GENT
by Honeywell

Technical Bulletin

TB:10204 I August 2015

New Vigilon, Compact panel software. MCC 4.53,LPC 4.49, RPT 1.09.

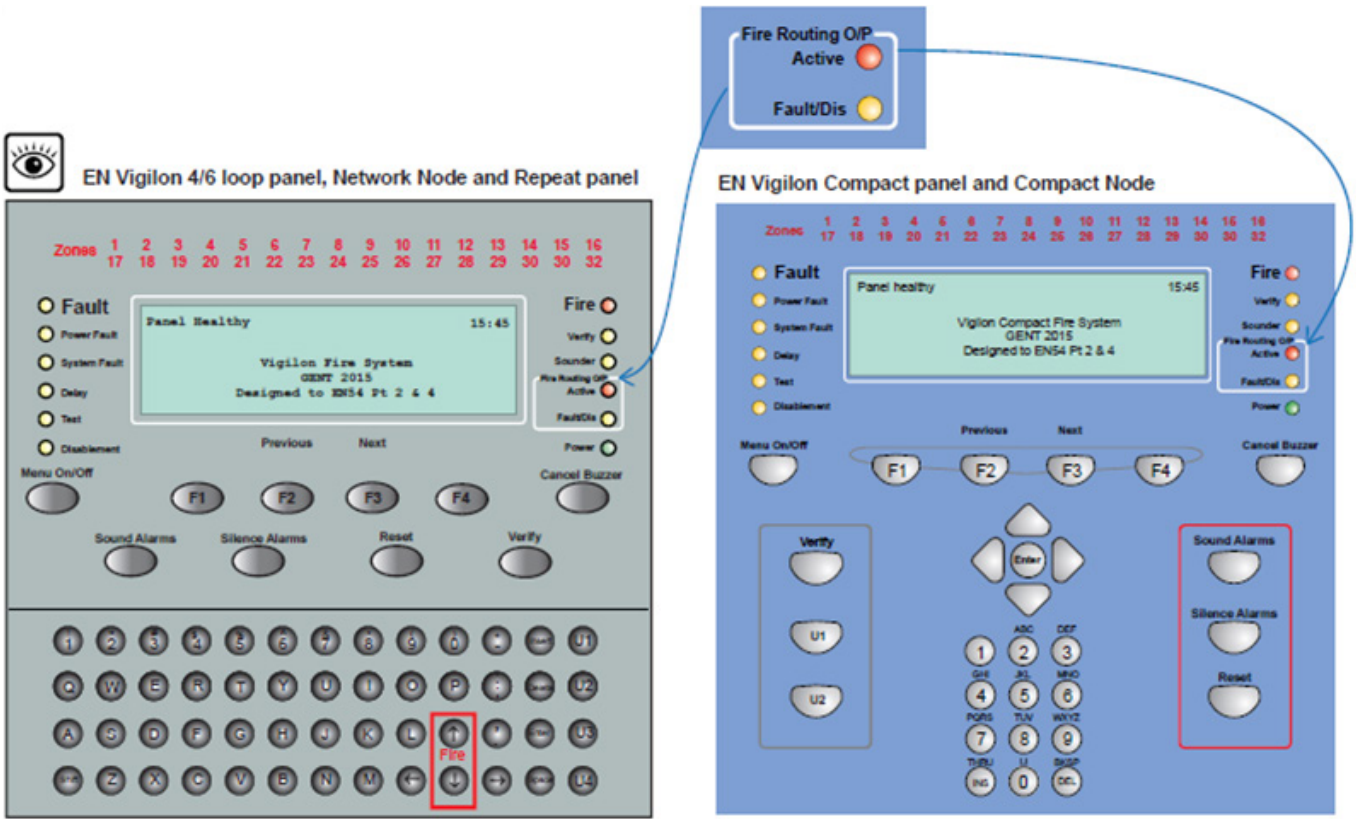
These changes also include a change to the membrane changing the text for CB253 & 254 LEDs to Fire Routing Outputs. The User defined keys with command build 253 and 254 is still possible and this will operate the LEDs now labelled as Fire Routing so care should be taken to label these LEDs to avoid confusion for the end User.

See image bellow:
